Melbourne Metro Rail Project

Inquiry and Advisory Committee

Expert Evidence Submission
Surface Water and Ground Water

Barry Fox – Drainage Engineer
12 August 2016

Figure 1 Concept Design Option - Western Portal

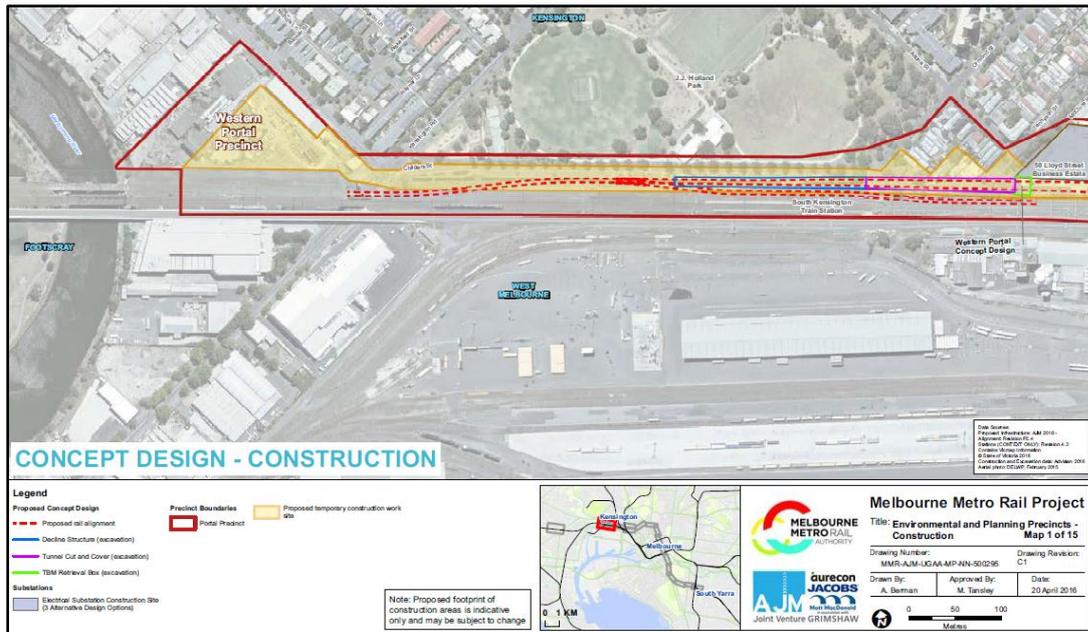
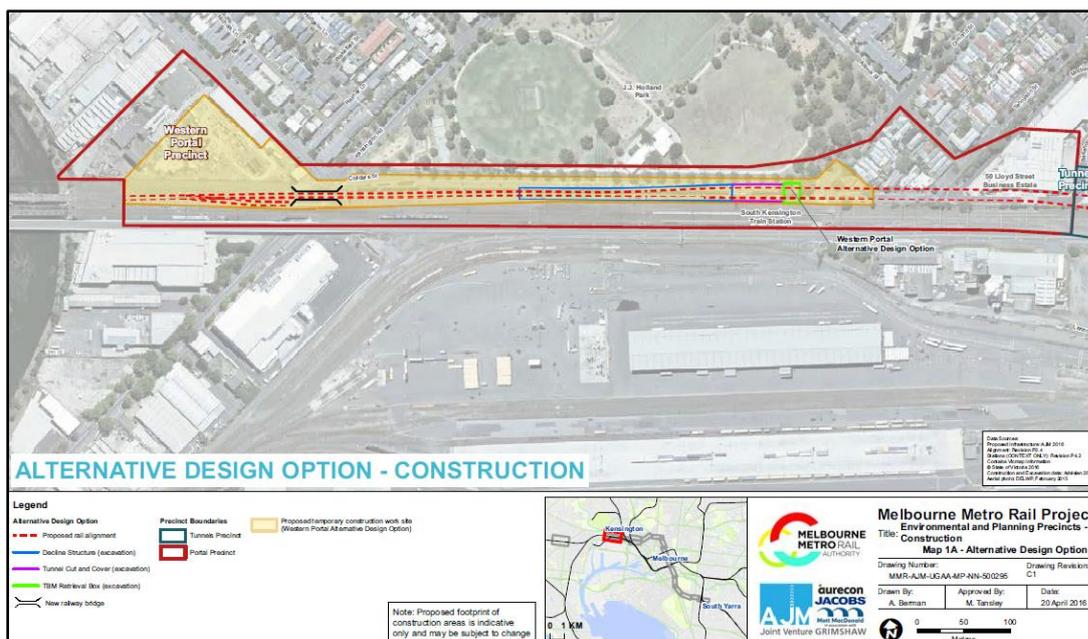
In terms of stormwater management considerations, the Alternative Design Option appears to have a lower impact on the floodplain as can be seen by the lower compensation storage requirement for this option of 7,000m³ versus 9,000m³ for the Concept Design Option. Both options appear to have similar impacts on the local drainage network and in that regard this submission does not offer a preferred option for the project to implement.

The EES quotes a storage volume of 180m³. The sizing of such a storage tank is dependent on the capacity of the existing local drainage at the point of connection, which will dictate the allowable rate of discharge into the Council drain. This rate can be provided by the City of Melbourne at detailed design stage. The other factor relevant to the ultimate sizing of the storage tank will be the magnitude of the rainfall event the MMRA deem reasonable to design for (e.g. 50, 100, 200, 1000 year ARI) and whether allowances for increased rainfall intensities due to the predicted effects of climate change are accounted for.

The drainage infrastructure required for the western portal's decline structure, including the detention tank, will remain under the ownership of the rail operator. As such, this infrastructure, insofar as is possible, should be located within land managed by the rail operator, and not Council managed land.

It is recommended that the stormwater detention tank required to allow controlled discharge of runoff from the decline structure to the local drainage network, be located within land controlled by the rail operator.

Figure 3 Arden Siding LSIO

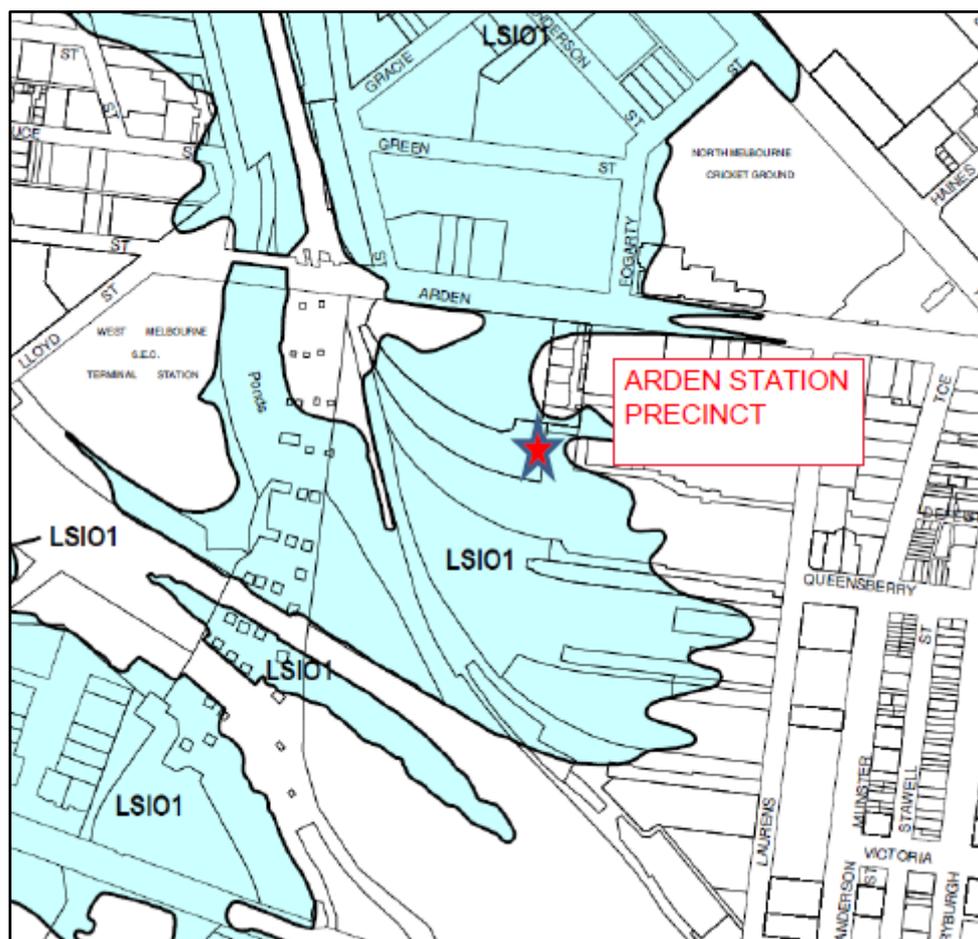
The majority of this land also sits within a LSIO in the Melbourne Planning Scheme, which designates land subject to flooding during a 1% Annual Exceedance Probability (AEP) flood in Moonee Ponds Creek. A 1% AEP flood is the magnitude of flood event that has a 1% probability of occurring in any given year. The LSIO extents at the Arden Station site are presented in Figure 3.

Figure 4 Arden Macaulay Flood Map with Substation Locations

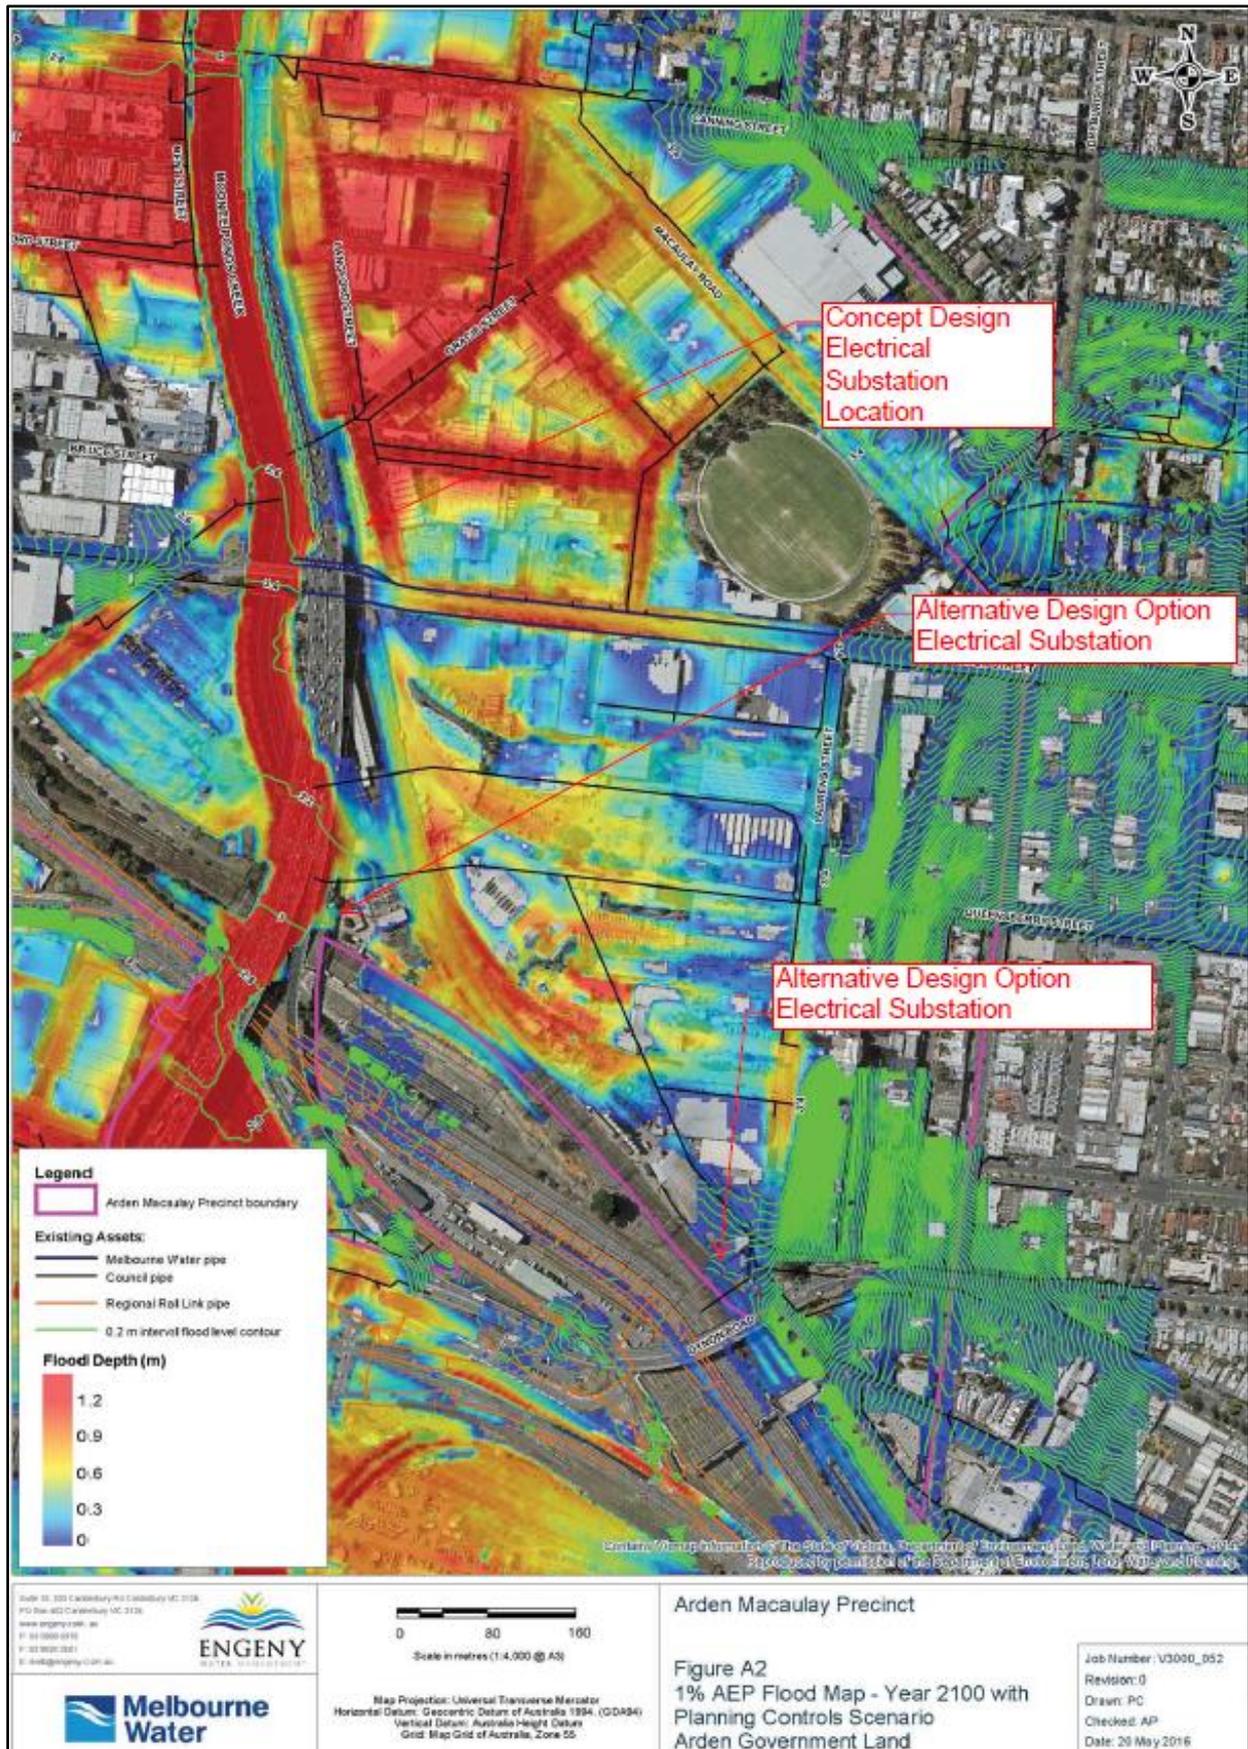
The flood map presented in Figure 4 below is taken from the Engeny Report. The map presents the 1% AEP flood extents around the Arden Siding site under future climate change conditions which account for predicted rising sea level (+0.8m) and increased rainfall intensity (+15.5%). The preparation of the flood model for this scenario assumes that 'Planning Controls' apply to all new development within the catchment, allowing for inclusion of on-site retention/detention systems as the only flood mitigation option.

Furthermore, the concept design location of the substation adjacent to Langford Street is in close proximity to the City of Melbourne's Langford Street pump station. This pump station has been identified as requiring upgrade, and planning works for this pump station expansion has commenced. One proposal under consideration for flood mitigation in the catchment is to connect Melbourne Water's Arden Street Main Drain to the Langford Street pump station to ensure the drain can discharge into Moonee Ponds Creek when water levels are high. This requirement for pumped discharge into the creek is likely to be exacerbated by predicted sea level rise in the tidal influenced lower reaches of Moonee Ponds Creek. To accommodate this additional flow, preliminary figures indicate that the pump station capacity will need to be increased from 0.7m³/s to 7m³/s. Increasing the pump capacity by a factor of 10 is likely to result in a significant increase in pump station footprint. Proceeding with the concept design option for the Metro Rail substation would likely limit the ability of City of Melbourne and Melbourne Water to undertake the necessary expansion of the pump station required to mitigate flooding in the Arden Catchment.

It is recommended therefore, that one of the alternative substation locations be adopted.

Figure 6 Arden Street Main Drain SBO and Parkville Station

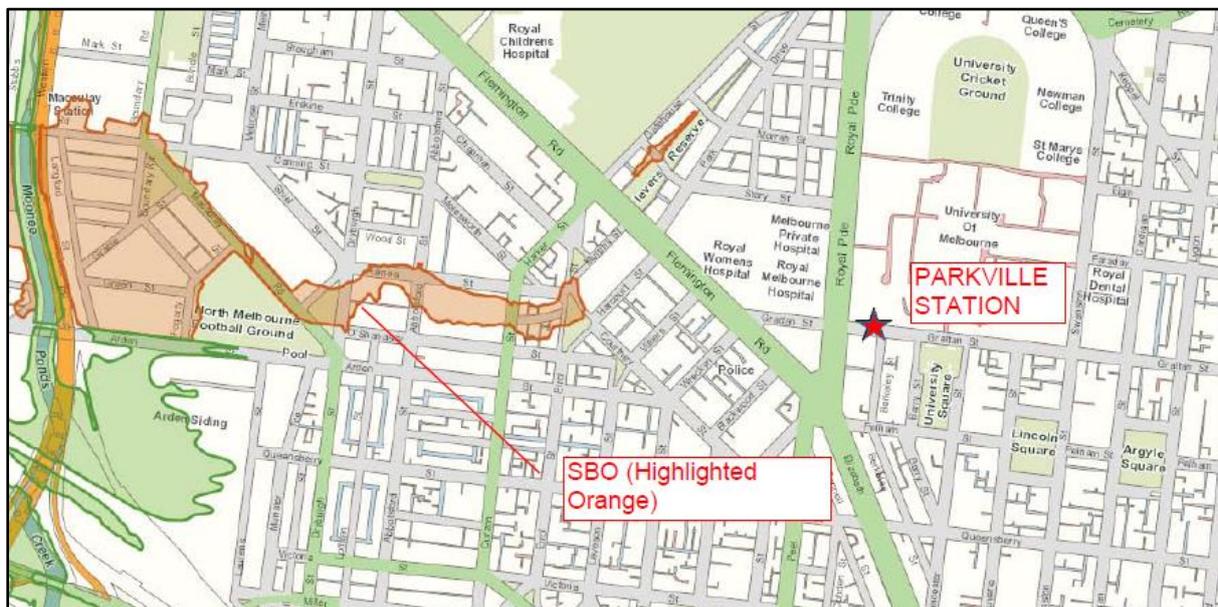
The Arden Street Main Drain is rated by Melbourne Water as being a 'High' flood risk catchment. With the Parkville Station being located towards the upstream end of this catchment, there is an opportunity to achieve a flood risk reduction benefit to the wider locality, which could be considered a legacy of the Metro Rail Project. Retaining runoff in the upper reaches of a catchment mimics the natural water cycle and reduces downstream flood risk.

It is suggested that this flood mitigation benefit would be delivered primarily through the provision of a stormwater retention system, incorporated into the station design to provide an alternative water supply source for use in toilet flushing, cooling towers, and any other non-potable water demands the station infrastructure may require.

Figure 9 Hannah St Main Drain SBO and Domain Station Precinct

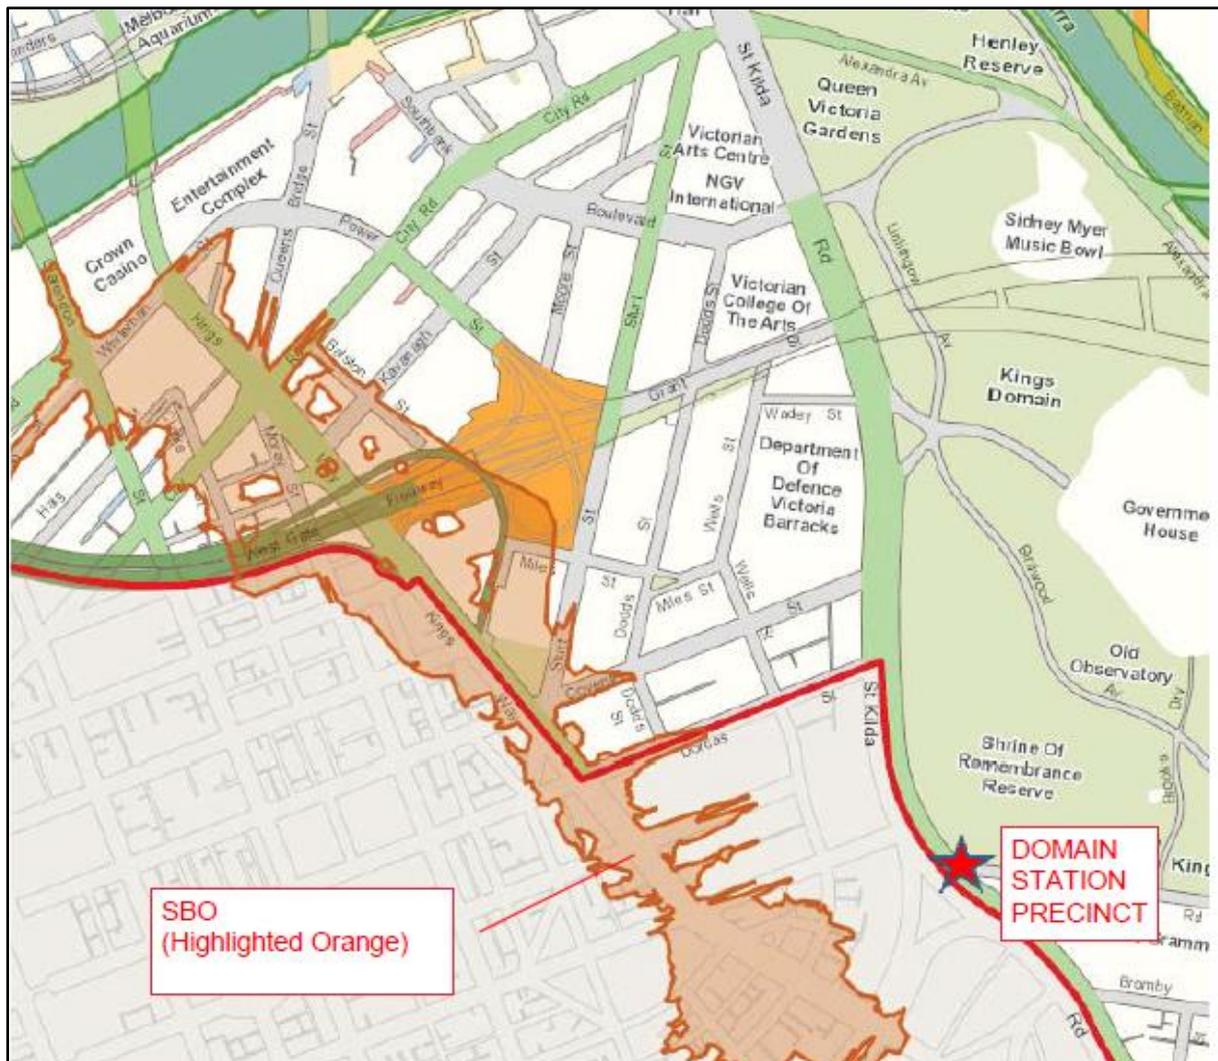
The HSMD catchment is rated as being a ‘High’ flood risk by Melbourne Water’s Flood Risk Assessment Framework. The location of the Domain Station within the HSMD catchment presents an opportunity for the station design to contribute toward reducing the flood risk in Southbank through the provision of stormwater retention and integrated water cycle management systems.

It is suggested that this flood mitigation benefit would be delivered primarily through the provision of a stormwater retention system, incorporated into the station design to provide an alternative water supply source for use in toilet flushing, cooling towers, and any other non-potable water demands the station infrastructure may require.
